Addendum 02

June 21, 2024

IFB 24-B0042

Market Common Tree & Sidewalk Replacement – Phase 1

L1.01

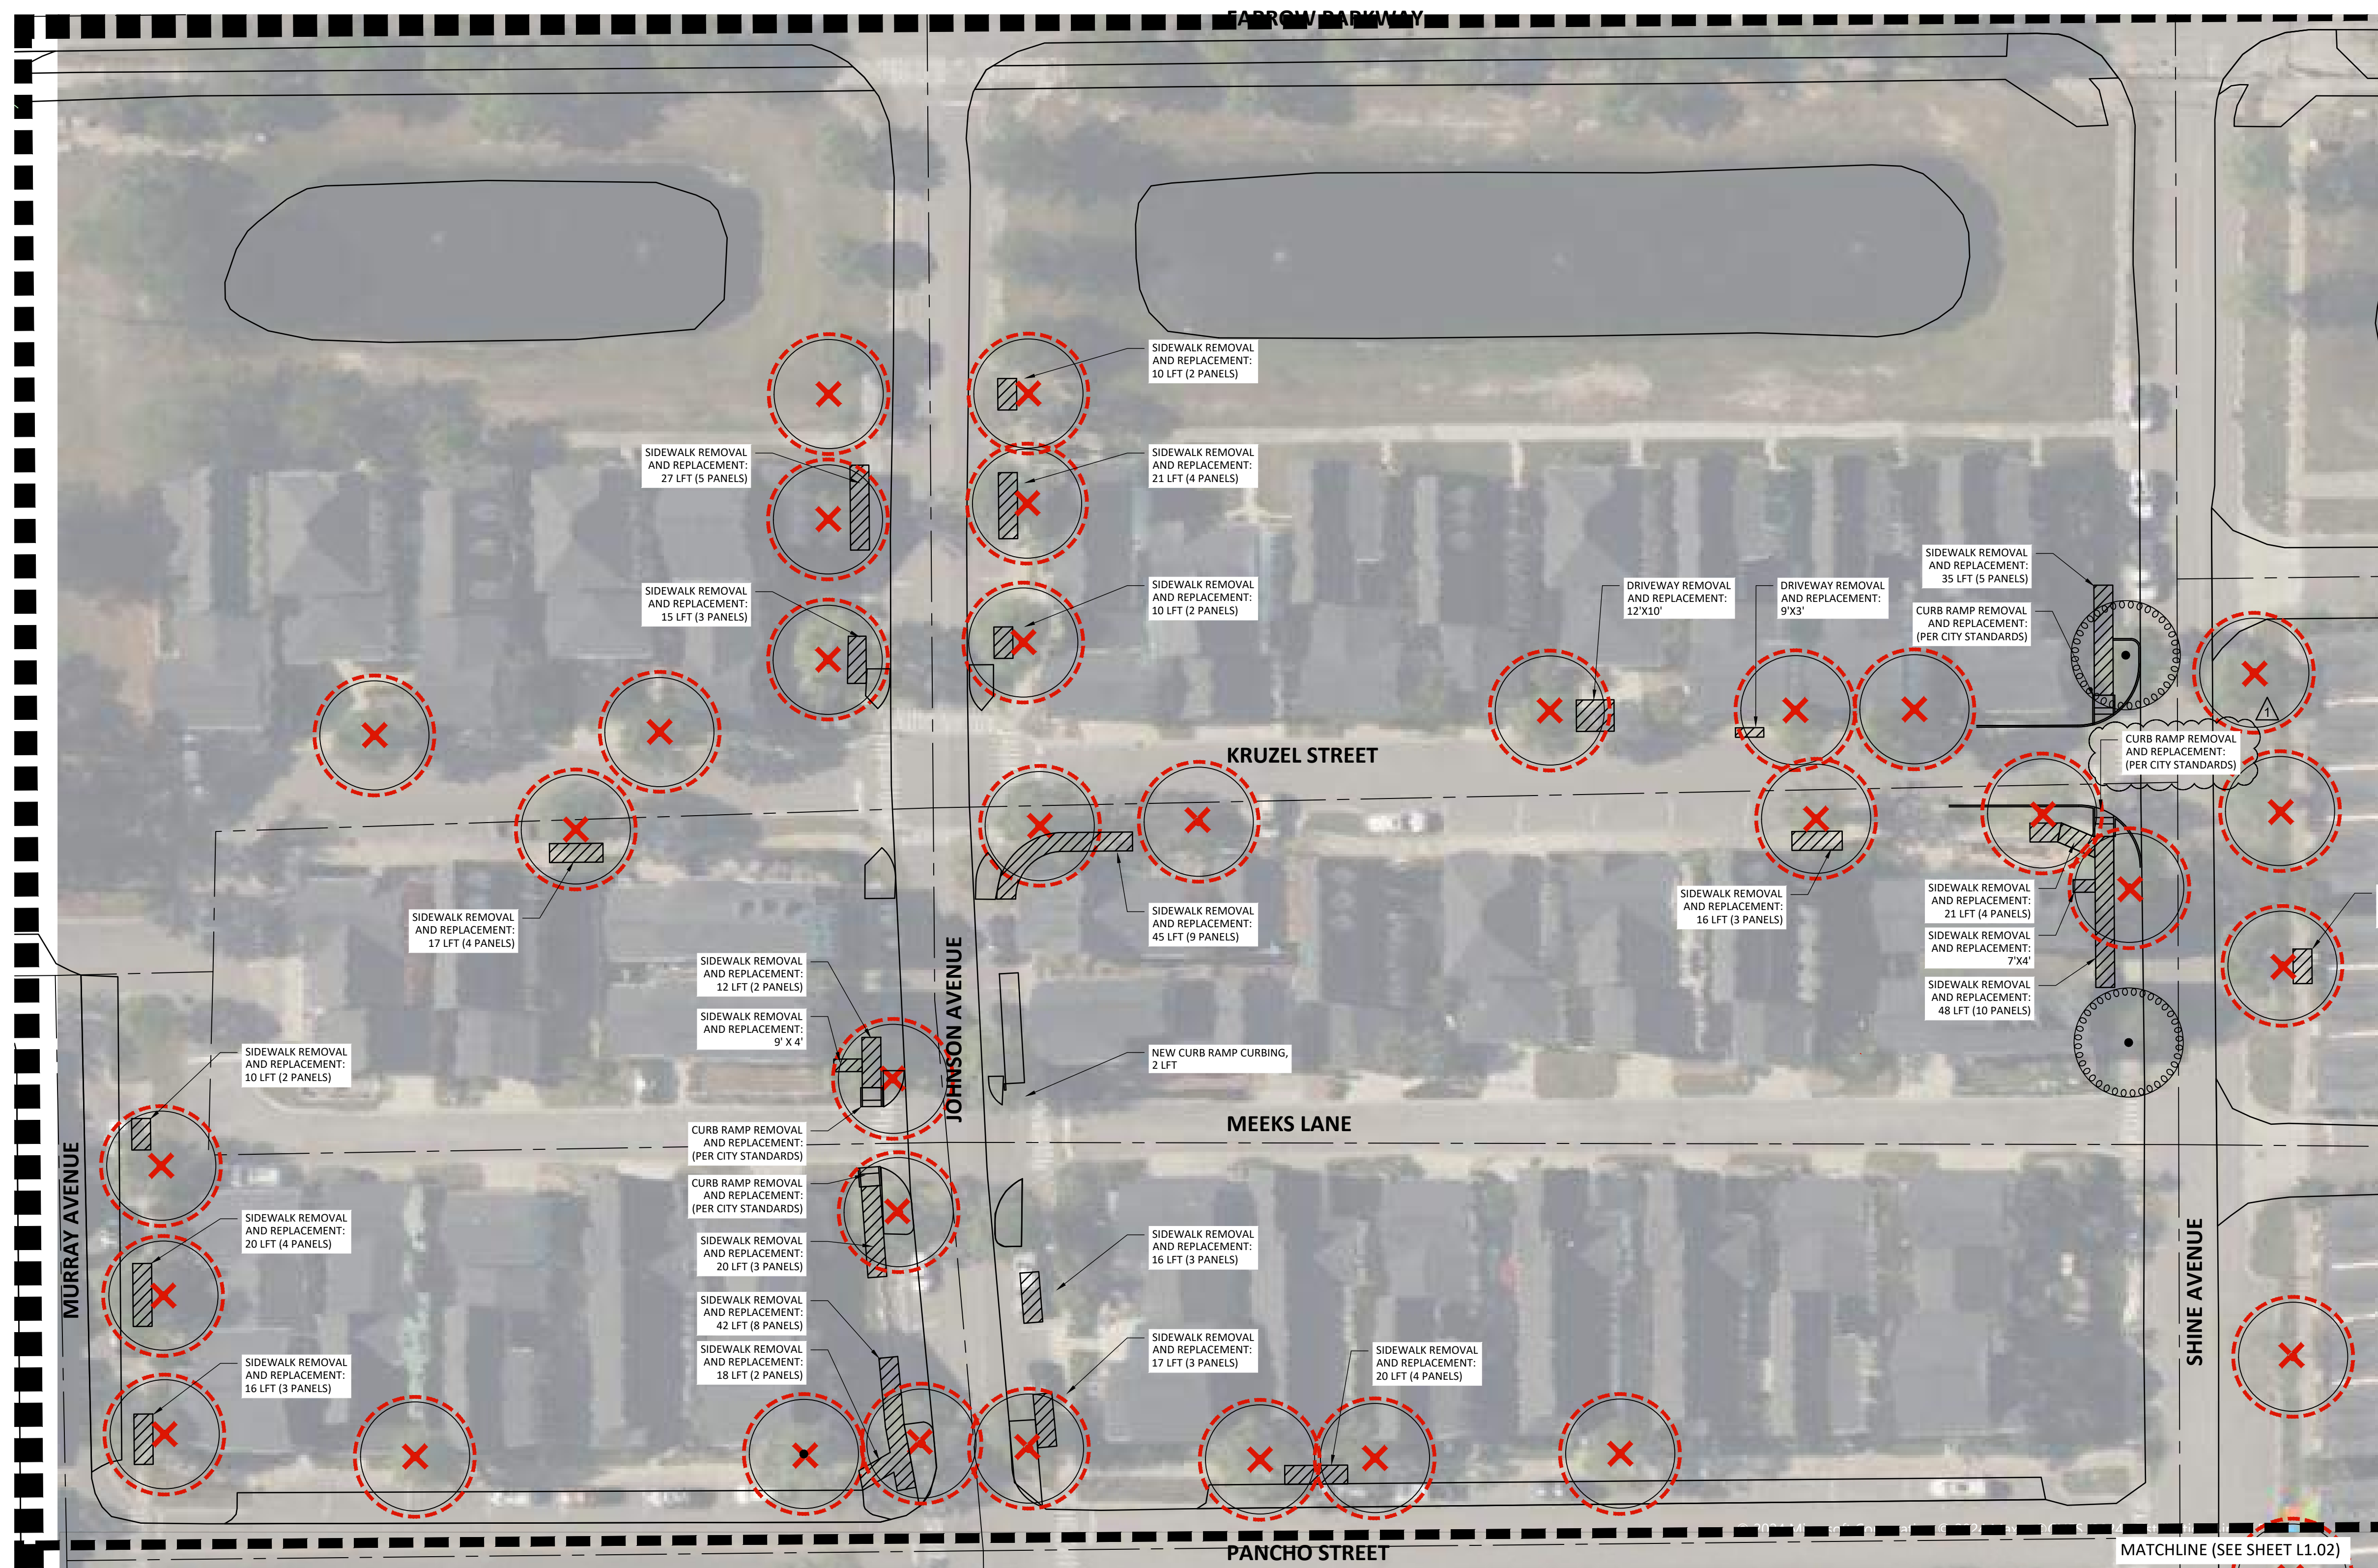
7. On page L1.01 Shine Ave & Kruzell St, it says Sidewalk Replacement, but it has an arrow pointing to the curb ramp that is located there now. Can you verify if this should be a curb ramp removal & replacement or a sidewalk removal & replacement?

Sheet L1.01 – Tree Removal and Sidewalk Replacement Plan has been revised: "Sidewalk Removal and Replacement: 10 LFT (2 Panels) Callout located at Kruzell Street and Shine Avenue intersection to read: 'Curb Ramp Removal and Replacement: (Per City Standards).'" Bidders are advised to refer to the updated section that has been attached to and hereby made a part of this Addendum.

L1.03

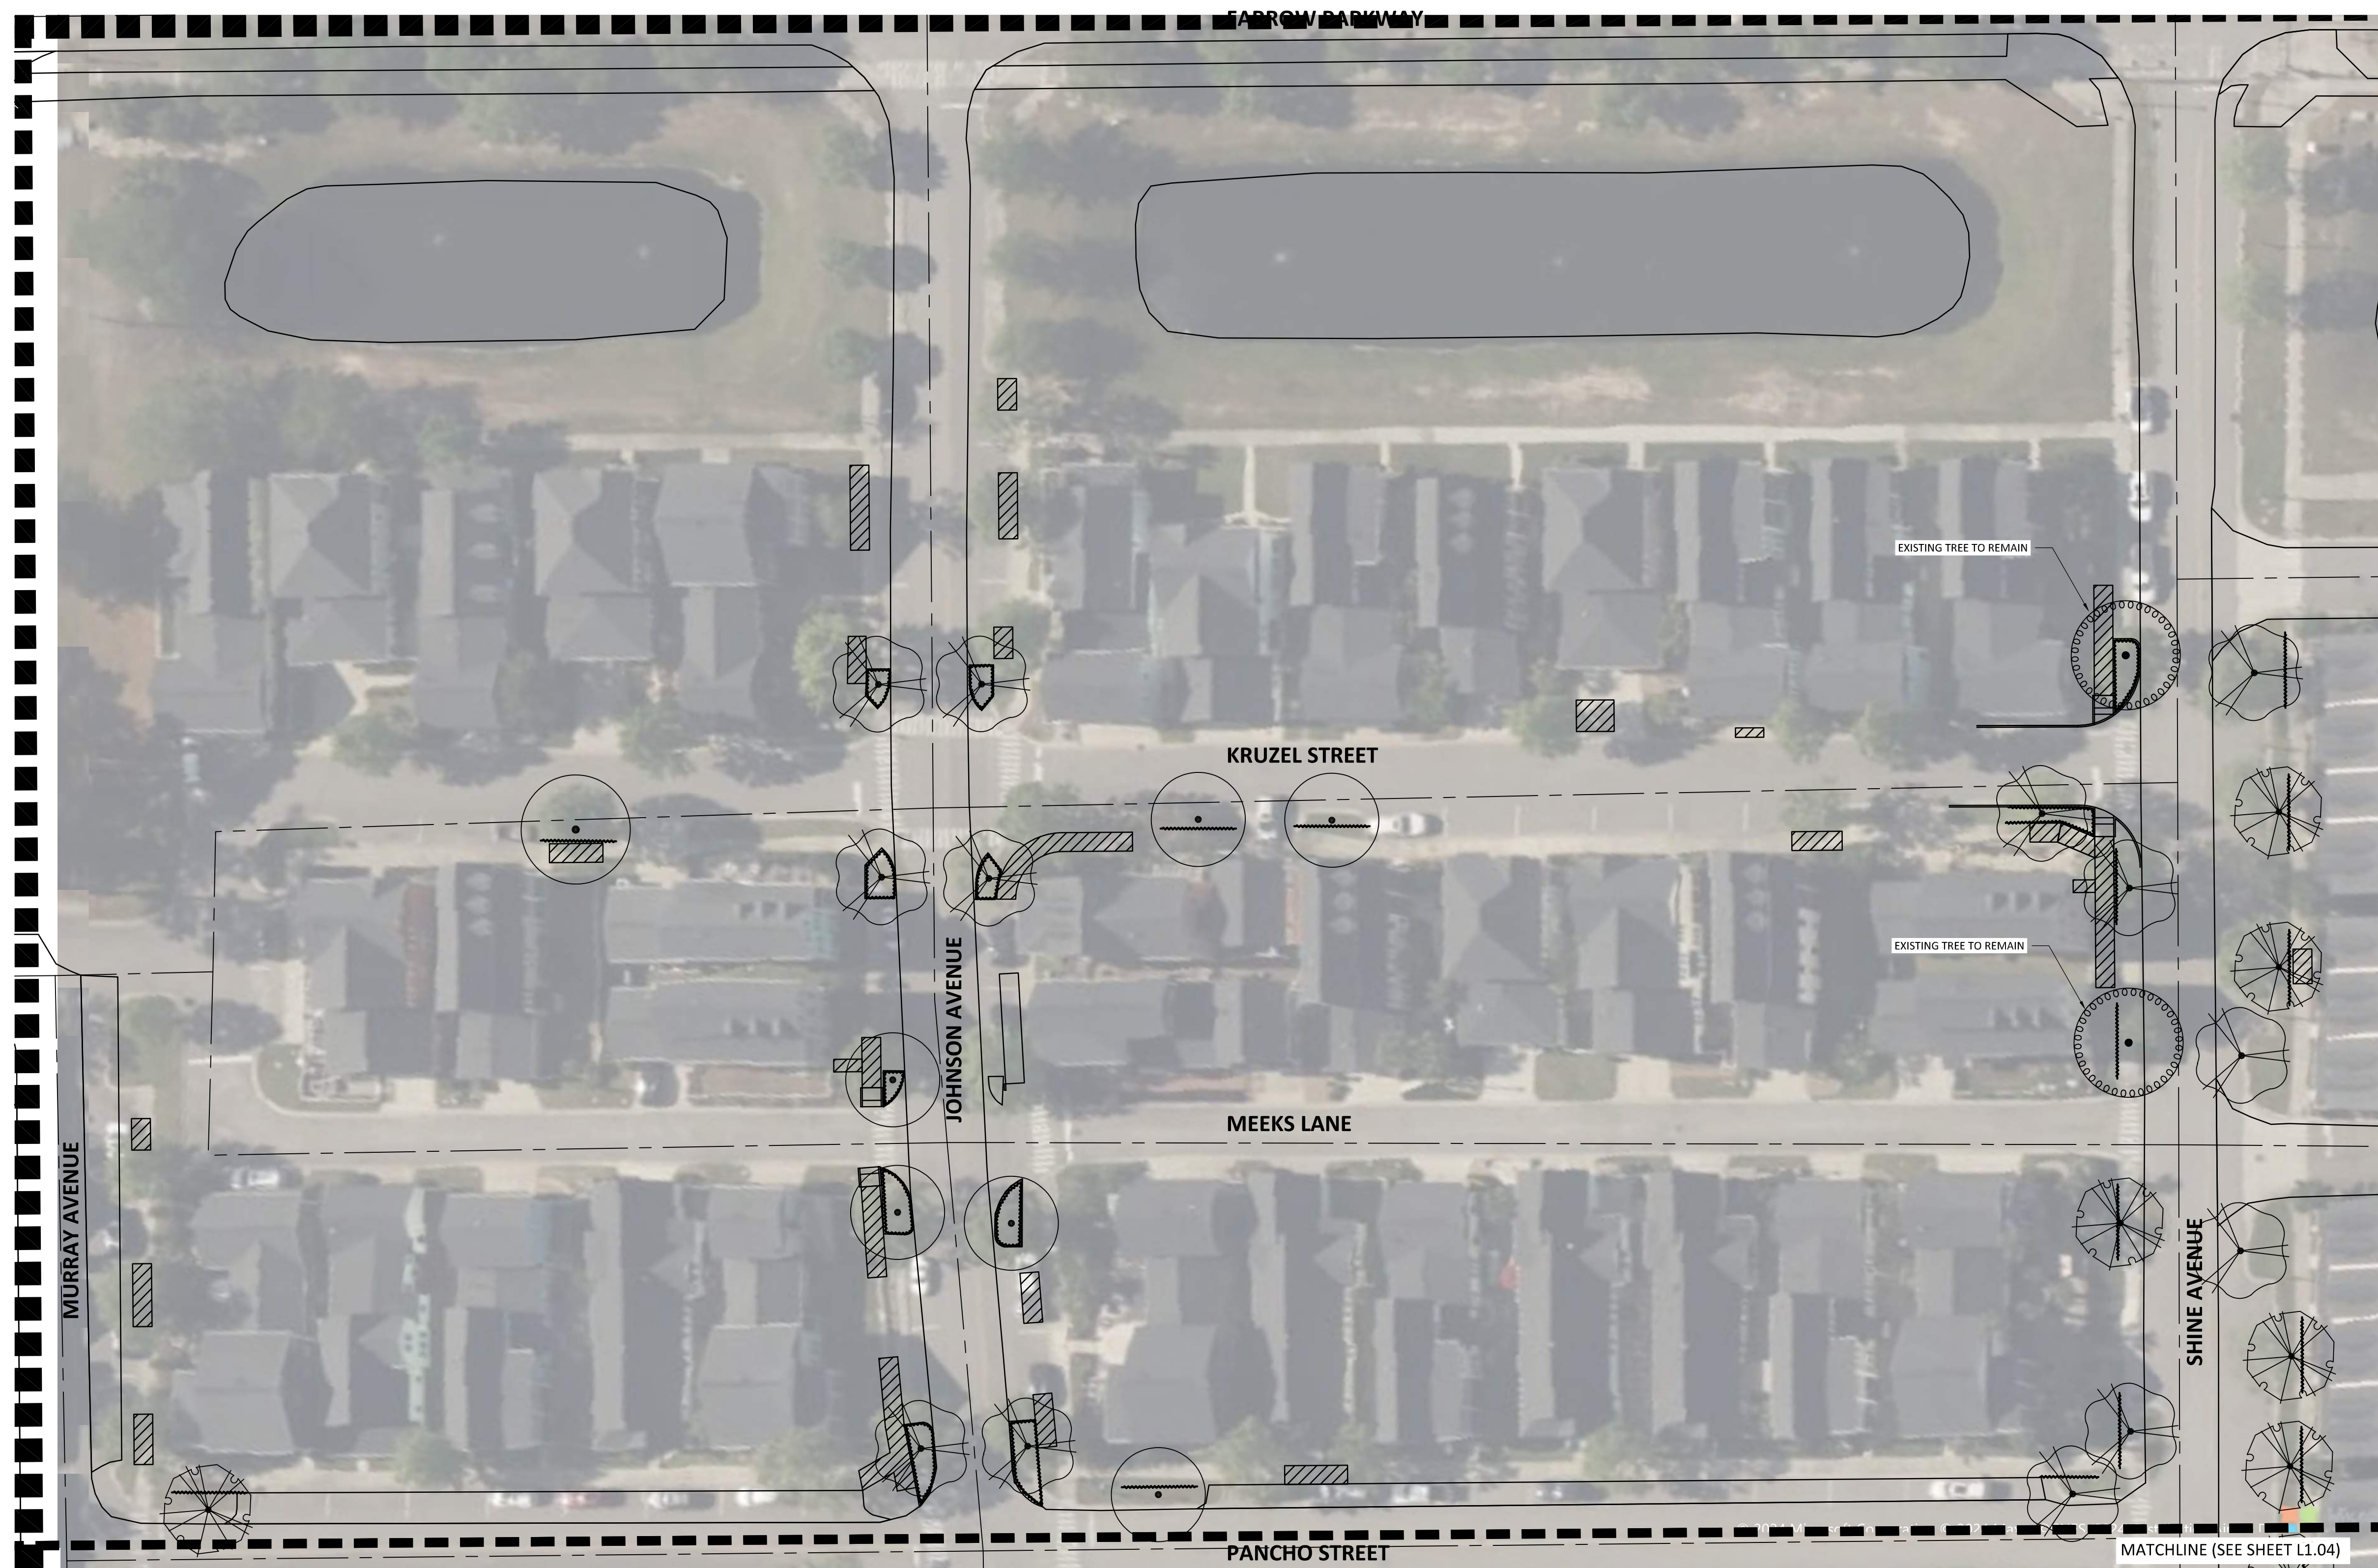
2. On page L1.03 there are two trees on Shine Ave not getting root barrier. Should these trees get root barrier or no?

3. If root barrier is needed for the two trees on Shine Ave will you be adding the extra linear feet to the bid tab?

The two trees located on Shine Avenue shown to not be receiving root barriers are located in a larger tree lawn area where root barrier is not required.

As stated in the response to Question 2, no root barrier is required for the two trees located on Shine Avenue.

- Sheet L1.03 to L1.05 – Landscape Plan, Plant Schedule: Revise tree quantities within the Plant Schedule as shown on the plan sheets that have been attached to and hereby made a part of this Addendum.
- Sheet C1.04 – Landscape Plan: Revise proposed tree symbol located at the southwest corner of Satterwhite Way and Shine Avenue shown on the plan sheet that has been attached to and hereby made a part of this Addendum.

LANDSCAPE NOTES AND DETAILS

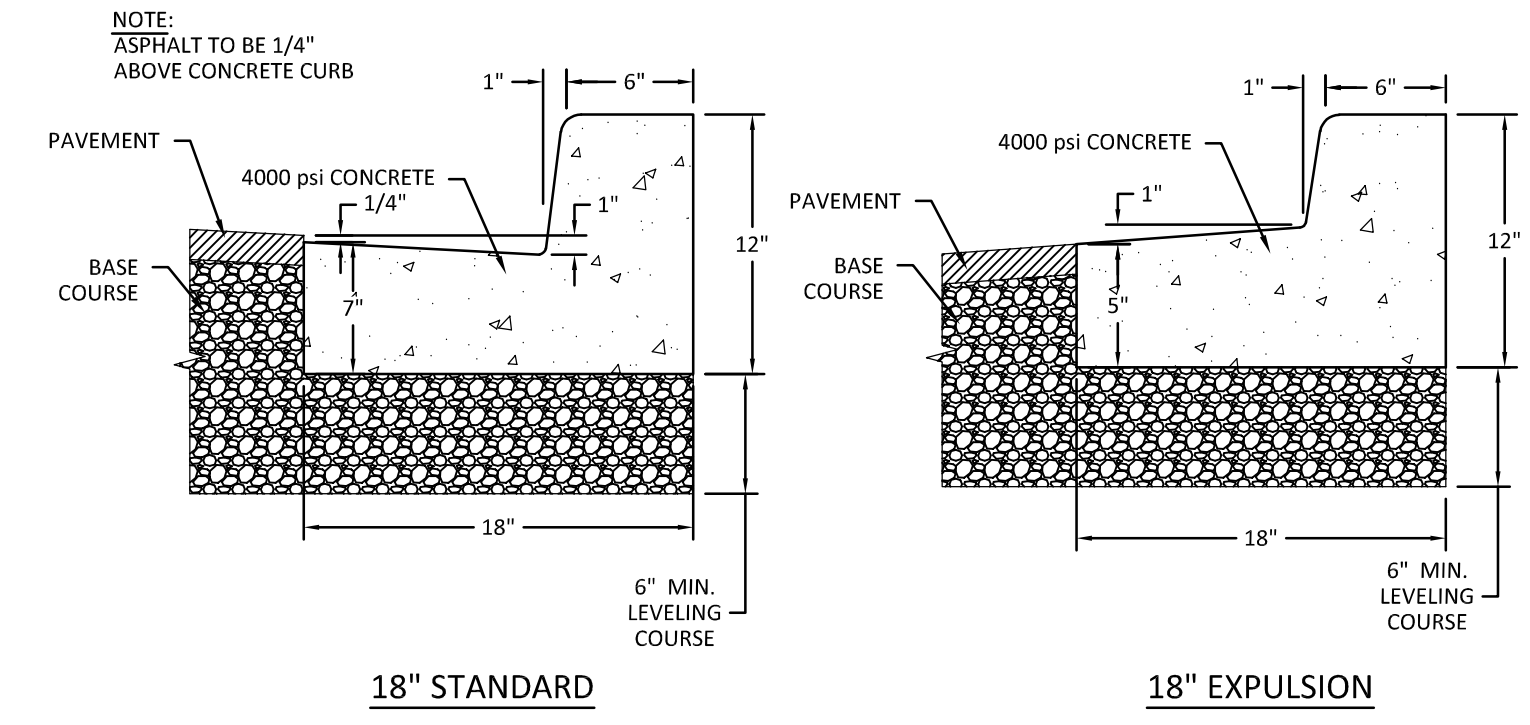
4. Why are not all the trees getting root barrier along the curb, sidewalk, walkways, pavement edges, and/or vehicular pavement edges like the specs on the plans call for?

Landscape note #16 on Sheet C1.05 – Landscape Notes and Details has been revised: “Provide root barriers anywhere shade trees and/or understory trees are planted within ten (10) feet of (measured perpendicular to) a sidewalk, walkway, pedestrian pavement edge, curb, and/or vehicular pavement edge. Provide eighteen (18) inch deep root barriers along sidewalks, walkways, curbs, vehicular edges, and pedestrian pavement edges. Minimum run of root barrier along edge of walk, etc., shall be twenty-four (24) lineal feet for overstory trees. Center root barrier run on the tree. For trees planted in parking islands with an area of up to and including 1,000 square feet, entire perimeter of island shall be protected with root barrier, regardless of the location of the tree.”

- ALL PLANT MATERIALS SHALL BE INSTALLED PER DETAILS INDICATED ON DRAWINGS.
- PROVIDE ROOT BARRIERS ANYWHERE SHADE TREES AND/OR UNDERSTORY TREES ARE PLANTED WITHIN TEN (10) FEET OF (MEASURED PERPENDICULAR TO) A SIDEWALK, WALKWAY, PEDESTRIAN PAVEMENT EDGE, CURB, AND/OR VEHICULAR PAVEMENT EDGE. PROVIDE EIGHTEEN (18) INCH DEEP ROOT BARRIERS ALONG SIDEWALKS, WALKWAYS, CURBS, VEHICULAR EDGES, AND PEDESTRIAN PAVEMENT EDGES. MINIMUM RUN OF ROOT BARRIER ALONG EDGE OF WALK, ETC., SHALL BE THIRTY-SIX (36) LINEAL FEET FOR OVERSTORY TREES. CENTER ROOT BARRIER RUN ON THE TREE. FOR TREES PLANTED IN PARKING ISLANDS WITH AN AREA OF UP TO AND INCLUDING 1,000 SQUARE FEET, ENTIRE PERIMETER OF ISLAND SHALL BE PROTECTED WITH ROOT BARRIER, REGARDLESS OF THE LOCATION OF THE TREE.
